5.5 Response to Submissions	14
5.6 Additional information	15
6. Assessment	16
6.1 Concept Approval modification (SSD 5175 MOD 4)	16
6.2 Retail centre modification (SSD 8588 MOD 2)	18

This report provides a concurrent assessment of applications to modify the Eastern Creek Business Hub Concept Approval (SSD 5175 MOD 4) and the State significant development (SSD) consent (SSD 8588 MOD 2) for a new retail centre at Rooty Hill Road South, Eastern Creek.

Figure 4 | Approved concept plan (left) and proposed (right) concept plan (SSD 5175)

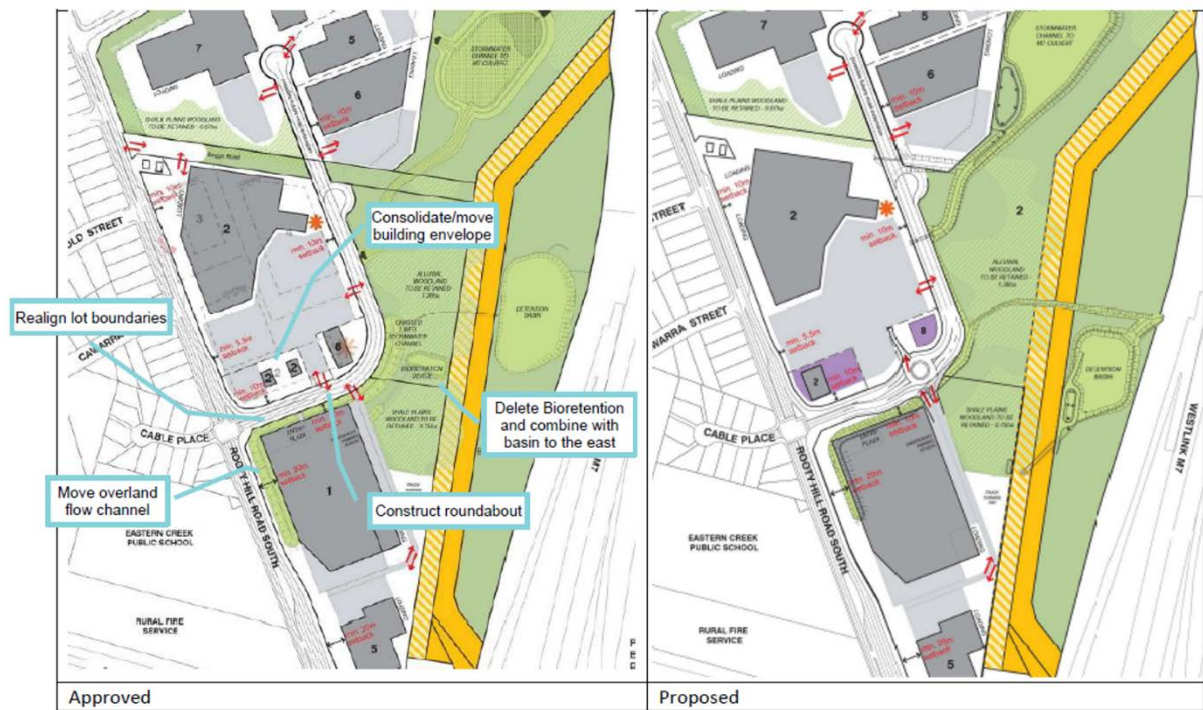
Transport for NSW (RMS) reviewed the modification application and raised concerns that as the roundabout is located only 100 m east of the signalised intersection on Rooty Hill Road South, queues from the roundabout will result in the roundabout functioning inefficiently and in turn negatively impact the signalised intersection at Rooty Hill Road South. Transport for NSW (RMS) requested the roundabout be located further east.

Two future development sites are located in the southern part of the carpark. The future development site in the south-west corner of the lot is proposed to be consolidated and moved to address the intersection of Rooty Hill Road South and the internal access road, while the site in the south-east corner is proposed to be moved east to facilitate the new roundabout access to the site (**Figure 4**).

The Applicant's RtS includes an addendum Traffic Study in response to the issues raised by Transport for NSW (RMS). The Applicant advises it is not possible to move the roundabout further east due to environmental constraints and to provide dual access to Lots 1 and 2. The Applicant believes the roundabout in its current location and the signalised intersection can perform at an acceptable level and accommodate traffic generated by the approved and proposed development on the site.

The Applicant has submitted amended concept plans and a detailed site plan for Lot 2 indicating entry only access to Lot 2 from the proposed roundabout, in accordance with the recommendation from Transport for NSW (RMS).

Figure 6 | Proposed changes to retail centre for Lot 2 (changes in red bubble) (SSD 8588 MOD 2)

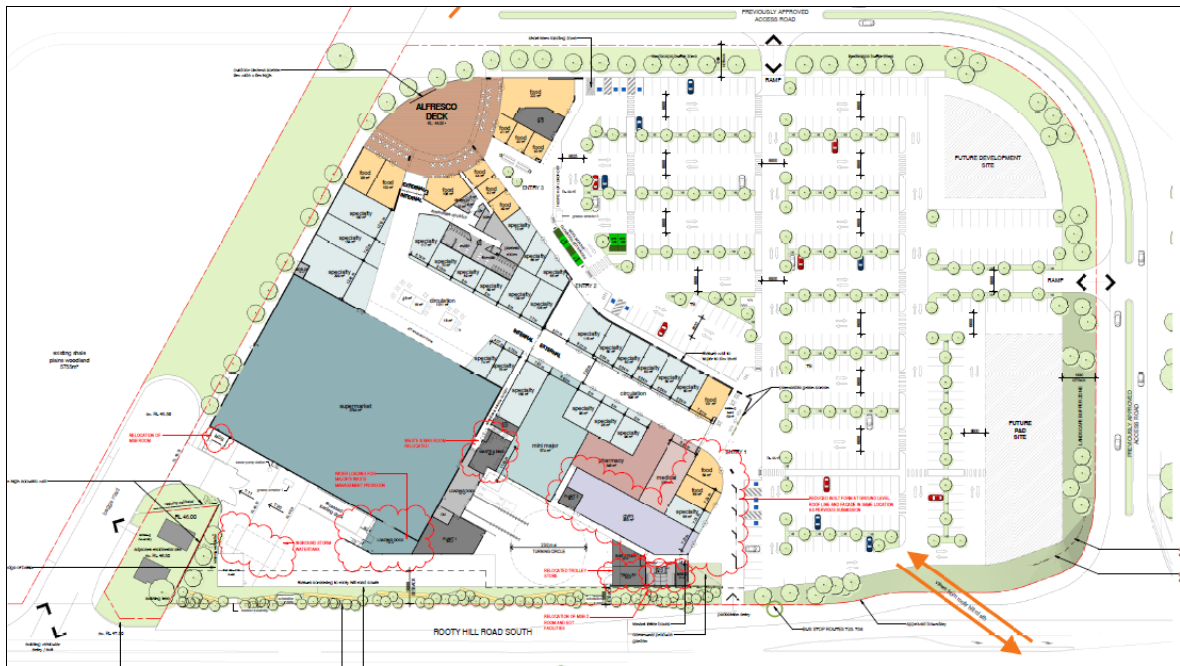
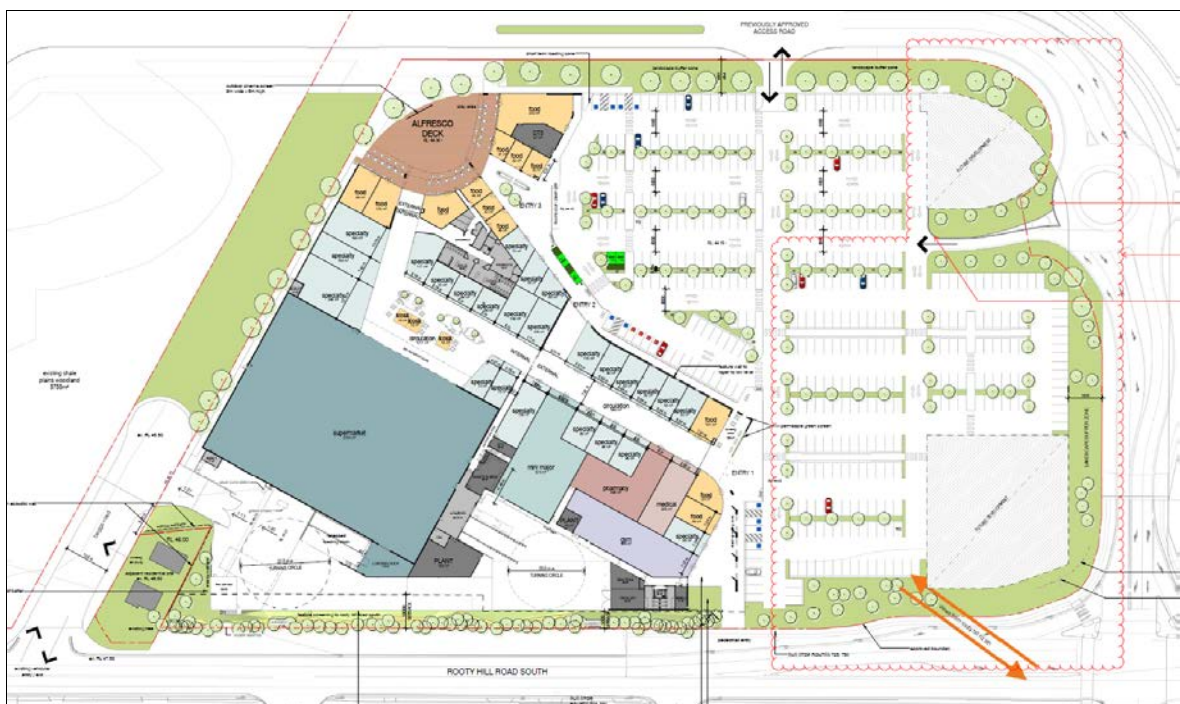
The new roundabout (proposed concurrently under SSD 5175 Mod 4) requires changes to the location of the future development sites and the layout of the carpark within Lot 2 (**Figure 6**).

The Applicant states the amendments do not result in any additional GFA, the revised layout will result in no significant changes to the carpark and will facilitate a future development which will better address Rooty Hill Road South.

The vehicle access arrangement has been modified to entry only to the site from the proposed roundabout, in accordance with Transport for NSW (RMS) recommendations. As discussed in **Section 6.1**, the Department is satisfied suitable vehicle access is provided for Lot 2.

The Department is satisfied the revised carpark layout is consistent with the design guidelines, provides sufficient car parking, suitable vehicle access, pedestrian connections and landscaping.
